EFFLUENT FILTER FINISH SCHEDULE						
AREA	FLOOR	BASE	WALLS	CEILING	CLG. HGT.	REMARKS
	CONCRETE QUARRY TILE	GLAZED CMU SOUND DAMPENING BLOCK (PAINTED)	BRICK WALL (EXISTING) - WEST WALL GLAZED CMU SOUND DAMPENING BLOCK (PAINTED)	BRICK WALL (EXISTING) - WEST WALL PRECAST PANELS (PAINTED) BAR JOISTS WITH STEEL DECK		
HALLWAYS					12'-8"	
FILTER ROOMS 9&10					12'-8"	
BLOWER ROOM					12'-8"	TO BOTTOM OF JOISTS
STORAGE ROOM					12'-8"

EFFLUENT FILTER DOOR SCHEDULE									
MARK	SIZE	MATL	TYPE	FINISH	FRAME		THRES	HDW SET	REMARKS
					TYPE	FINISH			
1	6070 X 1 3/4	METAL	2	PAINT	B	PAINT	ALUM	1	HOLLOW METAL
2	6070 X 1 3/4	METAL	1	PAINT	A	PAINT	ALUM	1	HOLLOW METAL
3	6070 X 1 3/4	METAL	2	PAINT	A	PAINT	ALUM	1	HOLLOW METAL
4	6070 X 1 3/4	METAL	2	PAINT	B	PAINT	ALUM	1	HOLLOW METAL
5	6070 X 2	METAL	1	PAINT	A	PAINT	ALUM	1	SOUND DOOR STC 45 INSULATED DOOR UNIT

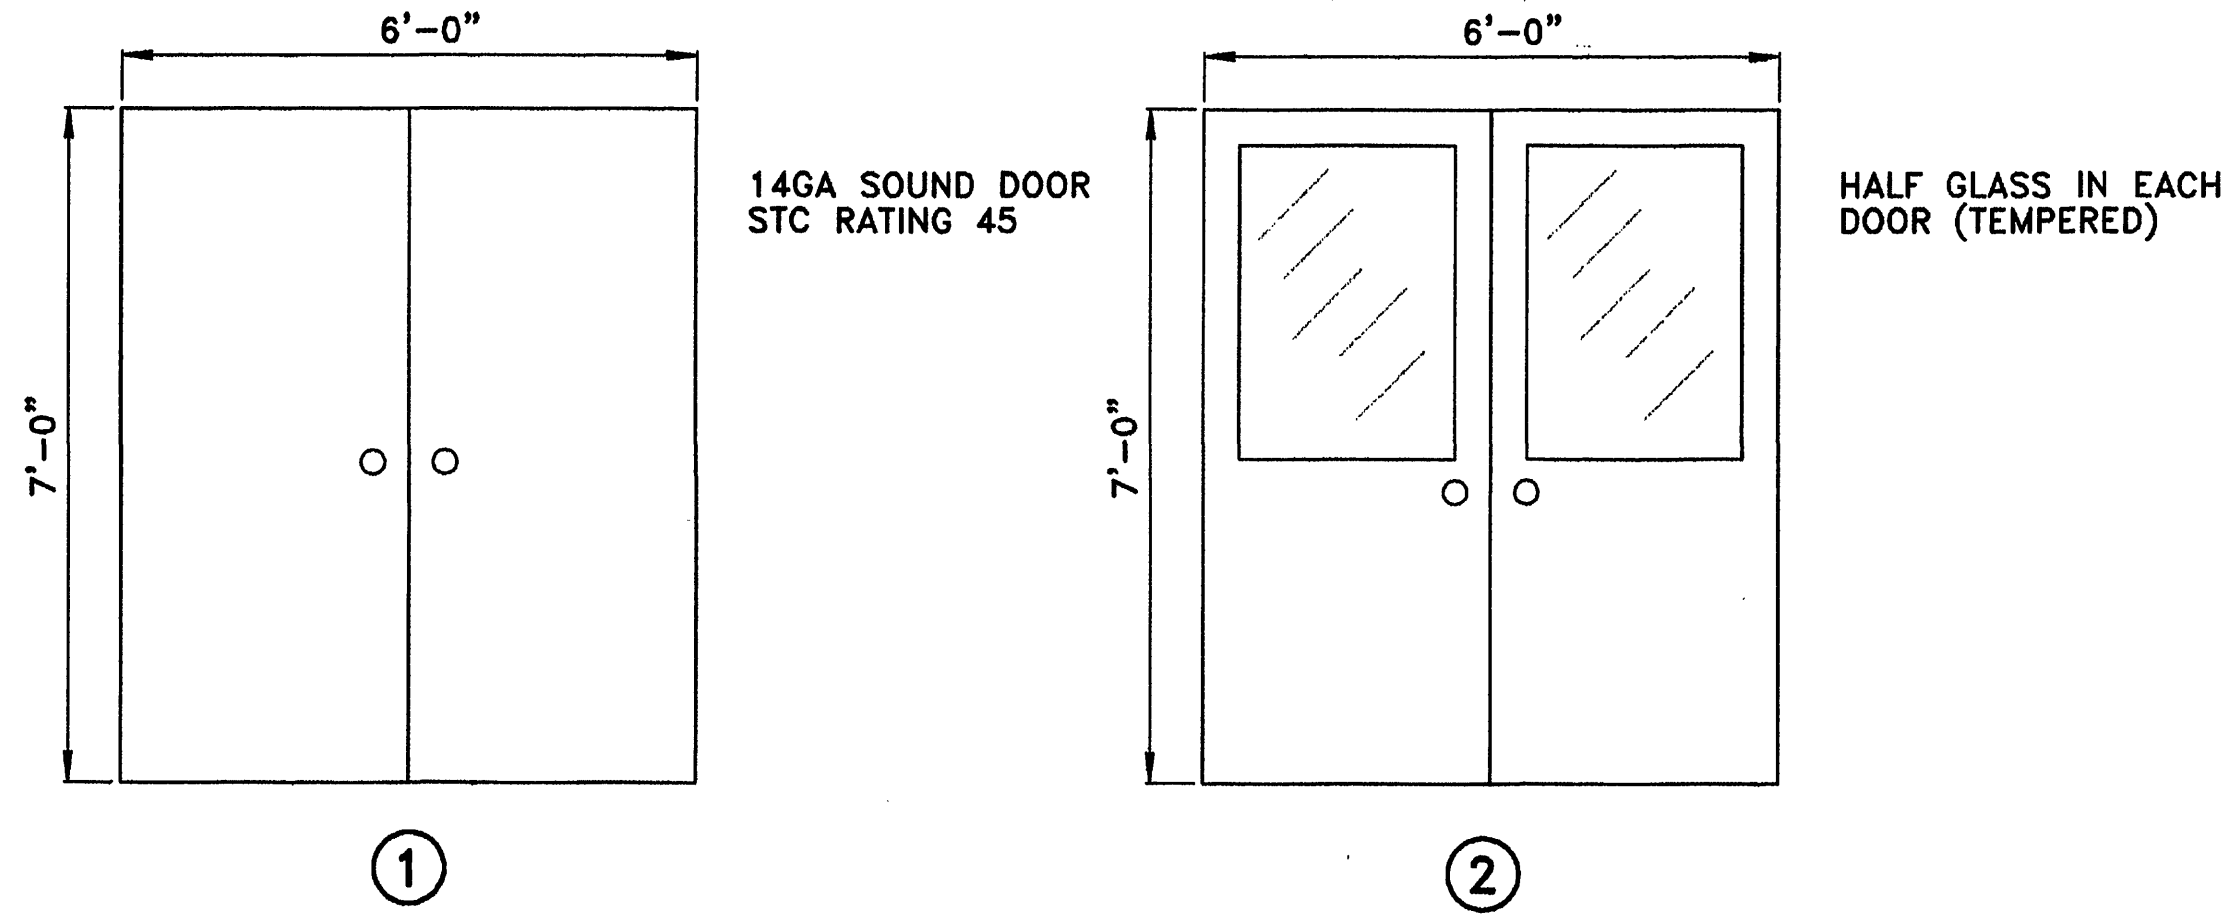
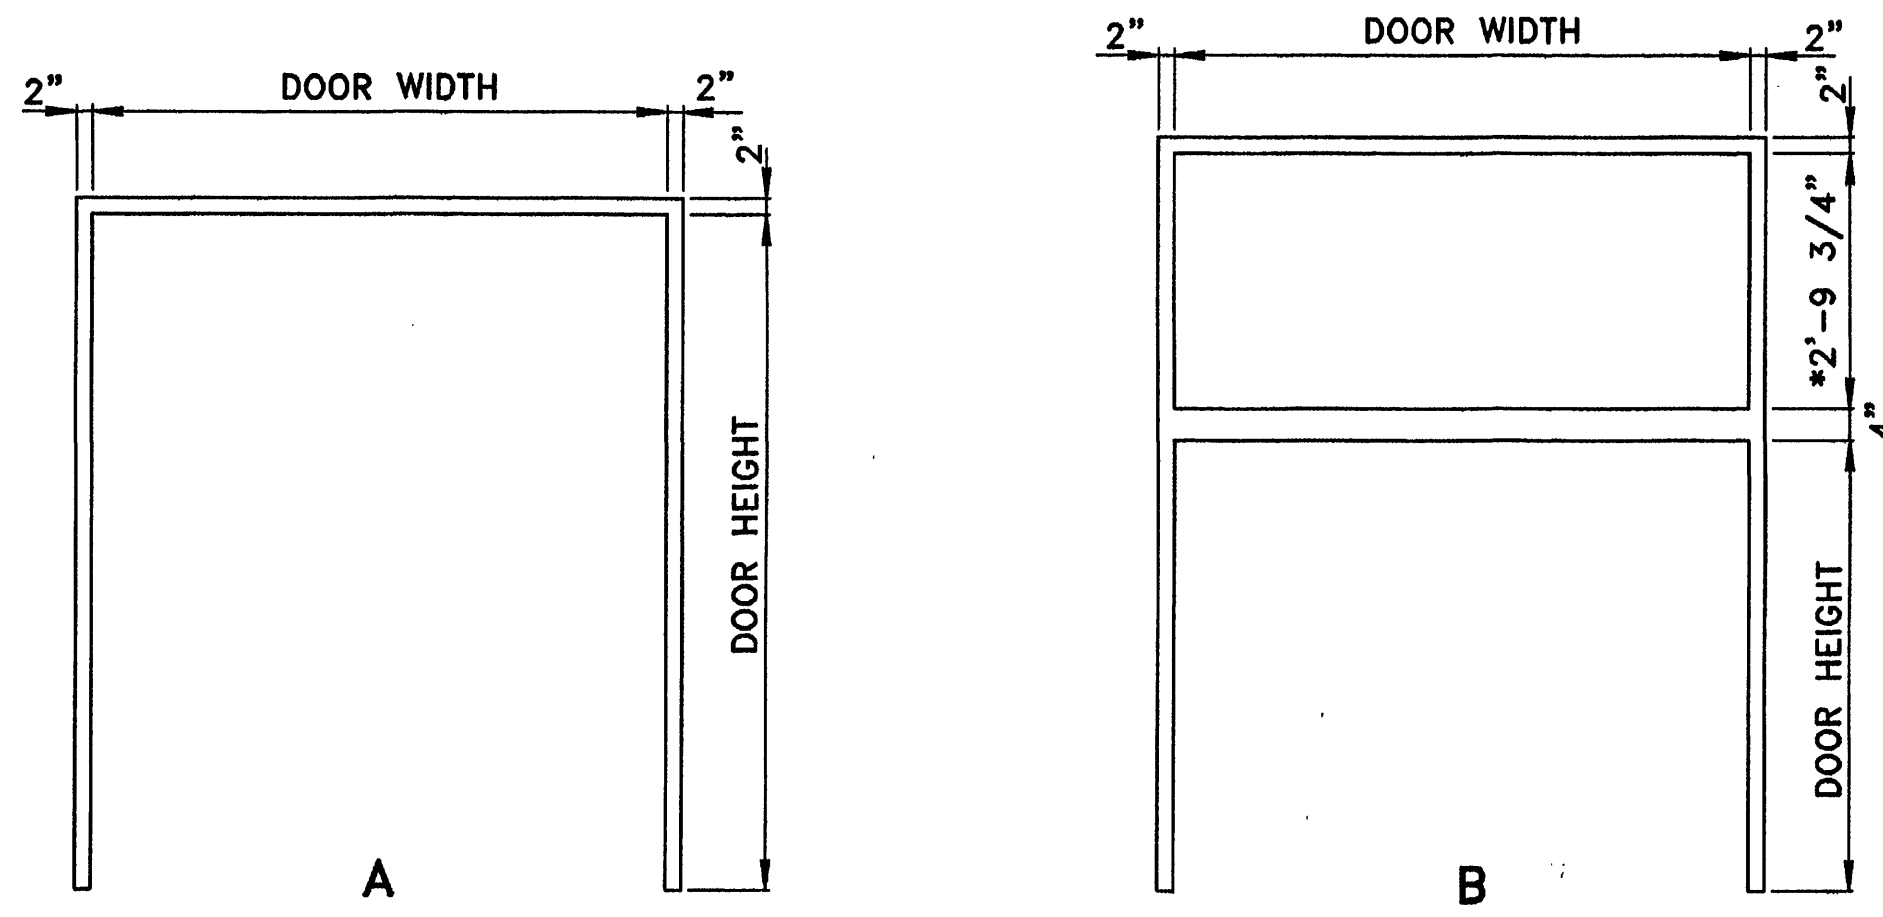
MAKE THE JOINTS ON THE GLAZED BLOCK UNIFORM AND MAKE THE COURSES OF THE FACE BRICK MATCH THE EXISTING AS CLOSE AS POSSIBLE.
PER RFI 126

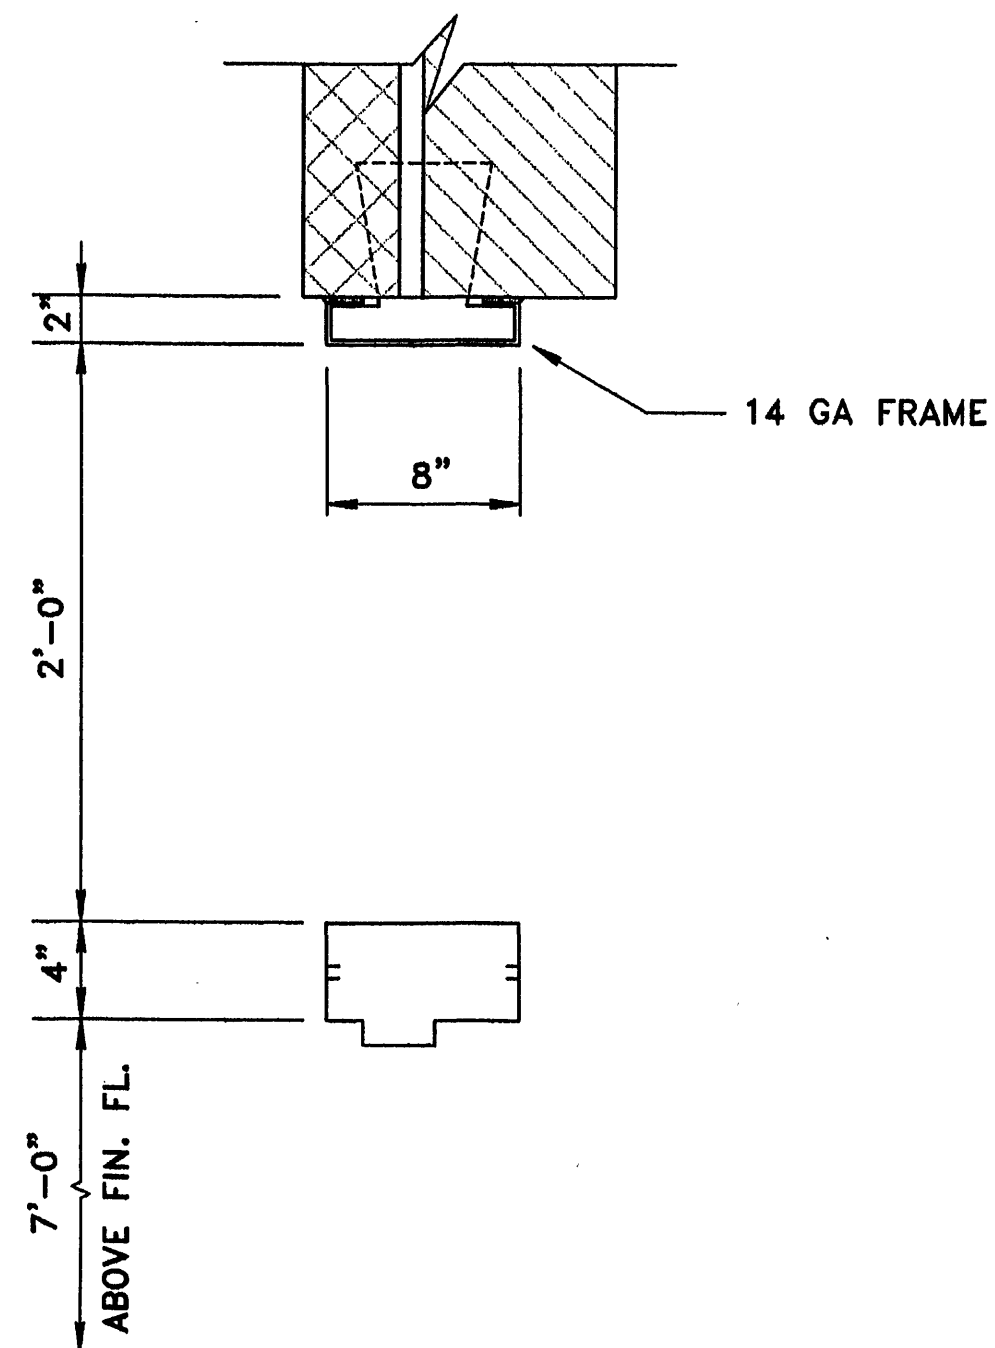
PER RFI 109
12/7/98
